<b>Application Number</b>	12/0489/FUL	<b>Agenda Item</b>	
<b>Date Received</b>	17th April 2012	<b>Officer</b>	Mr Toby Williams
<b>Target Date</b>	17th July 2012		
<b>Ward</b>	Petersfield		
<b>Site</b>	Former Cambridge College For Further Education 23 Young Street Cambridge Cambridgeshire CB1 2NA		
<b>Proposal</b>	Construction of three new buildings within Use Class D1 for non-residential educational and training use, following demolition of all buildings on the site except the Ragged School.		
<b>Applicant</b>	Bishop Hall Properties Bishop Hall Lane Chelmsford Essex CB2 8PA

SUMMARY	<p>The development accords with the Development Plan for the following reasons:</p> <ul style="list-style-type: none"> <li><input type="checkbox"/> The previous reason for refusal relating to the impact on Brunswick Nursery has been overcome through the revised design of the building</li> <li><input type="checkbox"/> The revised design does not raise any new issues in terms of design or amenity</li> </ul>
RECOMMENDATION	APPROVAL

Revised Section DD  
 Through Brunswick Nursery and Phase 3 Looking West. Scale 1:100 @A1

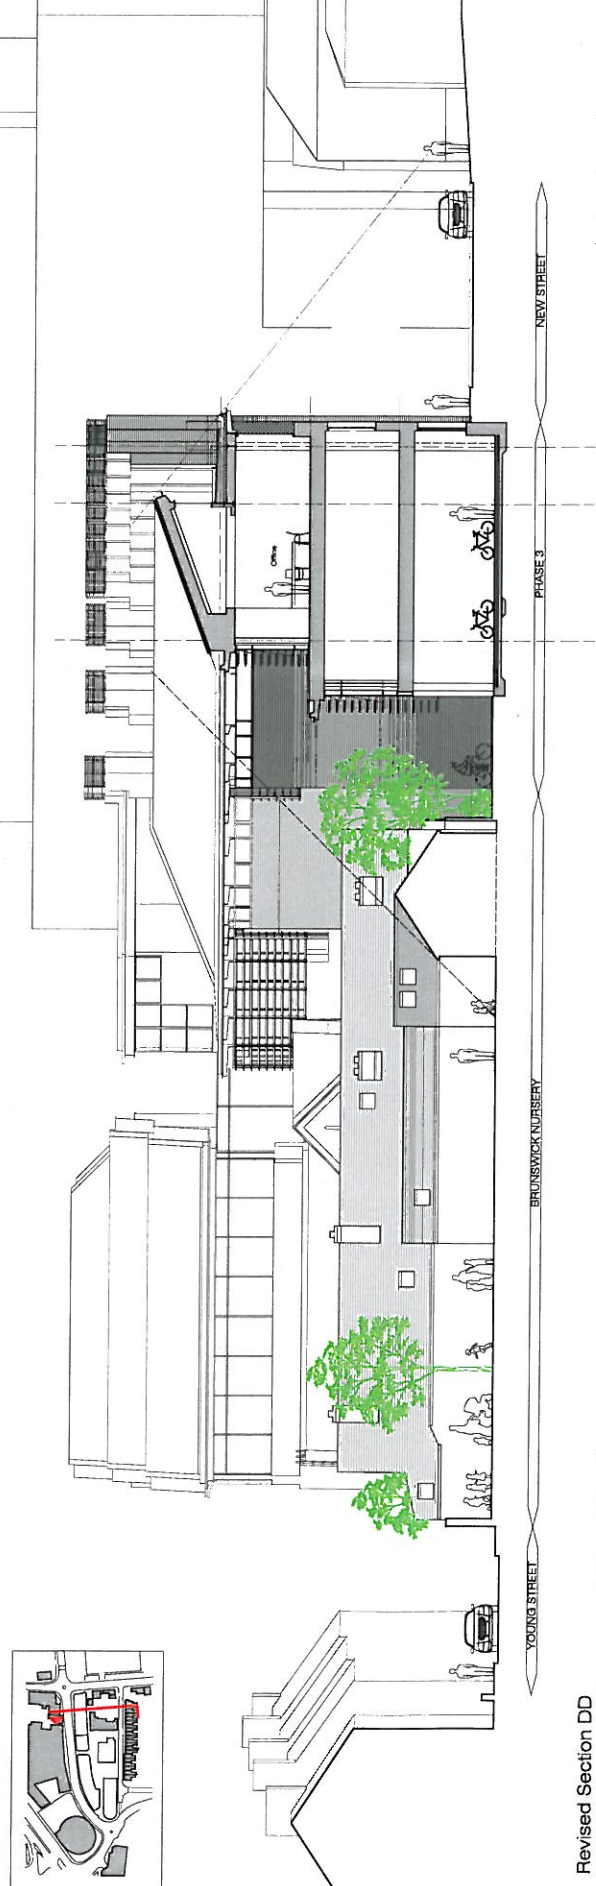
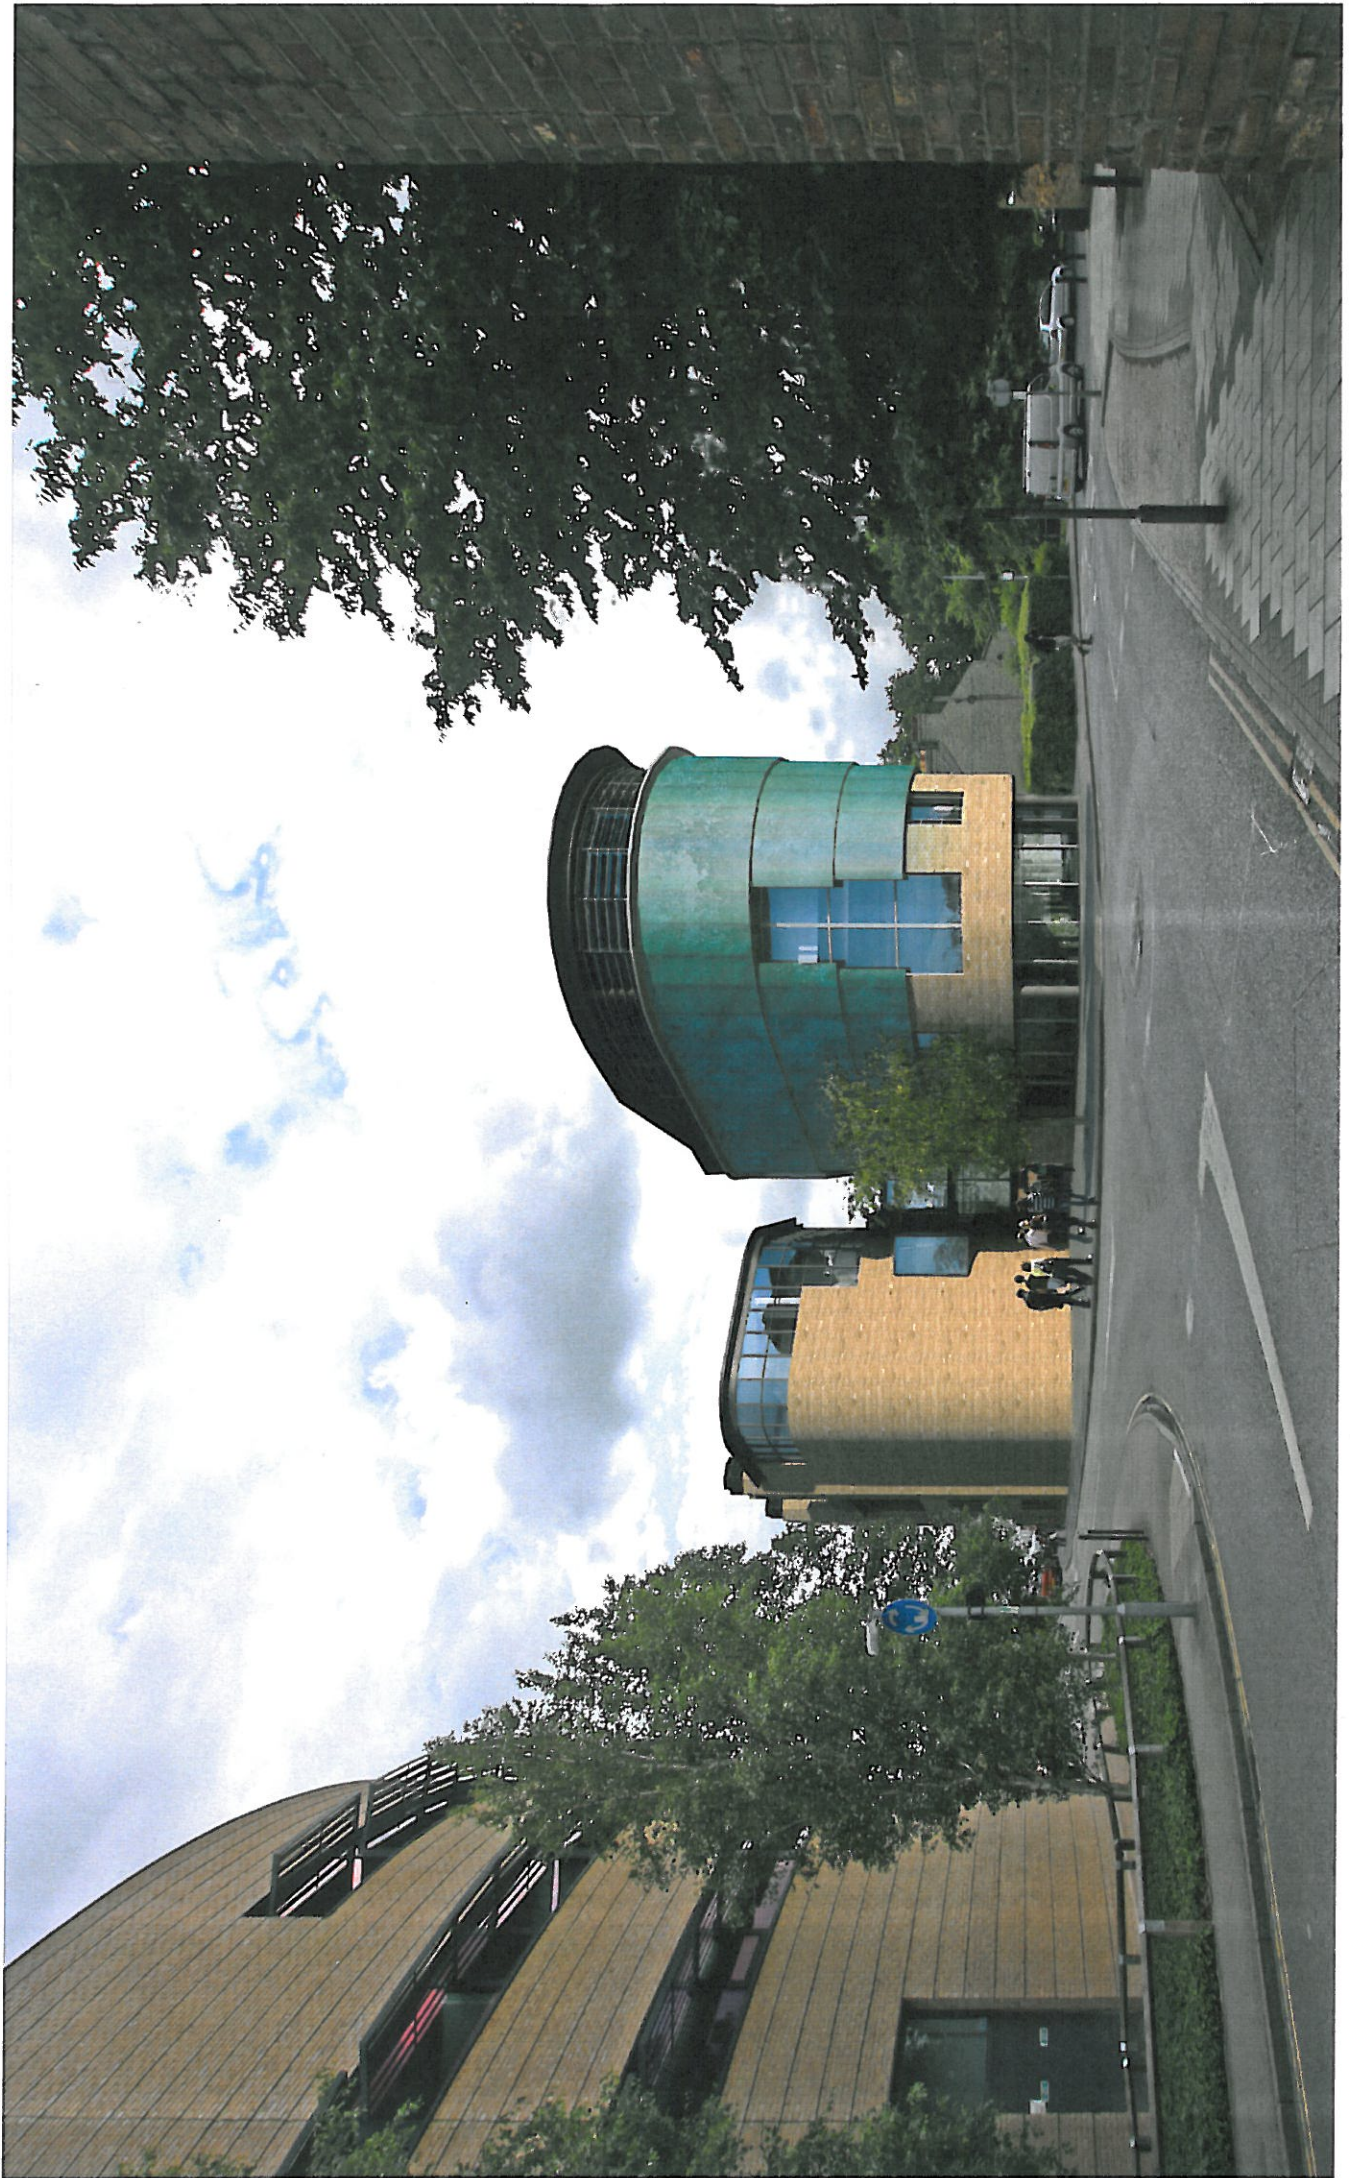
8.57 The refusal of planning permission related to an objection from the nursery relating to the height and bulk of the phase 3 building, its overall massing and dominance.

8.58 In relation to the revised scheme, the applicants have sought to address the reason for refusal by reducing the length of the eastern stair core on its southern flank from 14.5m to 10.5m. The eastern stair core has also been moved off the boundary with the nursery by 1.4m to the north, which has marginally narrowed the overall width of phase 3 at ground and first floor levels by 1m. A small area of landscaping is also now proposed adjacent to part of the Nursery boundary. As such, the mass of brickwork adjacent to the Nursery has been reduced, the proximity of the phase 3 improved and its impact mitigated by limited planting. A number of supporting plans illustrate the differences between the old and new schemes.

- 8.62 Notwithstanding the revisions and the lack of an objection from the Nursery, I still consider the impact on the garden of the nursery to be a balanced judgement, especially given the consistent height (13.5m) and length (51m) of the phase 3 building, neither of which have changed with the revised scheme.

- 8.60 The nursery and its garden are due south of phase 3. The applicants have submitted a sunlight shadow analysis, which demonstrates minimal sunlight impact from the development site on the nursery and Young Street properties. The proposed scheme has sought to minimise its impact on the garden of the nursery by setting back the 2<sup>nd</sup> floor façade from the boundary with the nursery (this does not represent a change from the previous scheme). This, together with the shallow mono-pitch roof and proposed fixed wooden louvres to the facade, will provide relief to the massing of the building as perceived from the nursery garden. The application includes a cross-section through the nursery garden and the proposed development. This demonstrates that for the majority of the garden, a clear 45-degree line of view over the top of the development is achievable.

- 8.61 The revisions to the scheme improve the relationship between the Nursery and the building. After due consideration of the new plans submitted by Anglia Ruskin University, the Brunswick Nursery School have agreed that there is no objection to the revised plans.
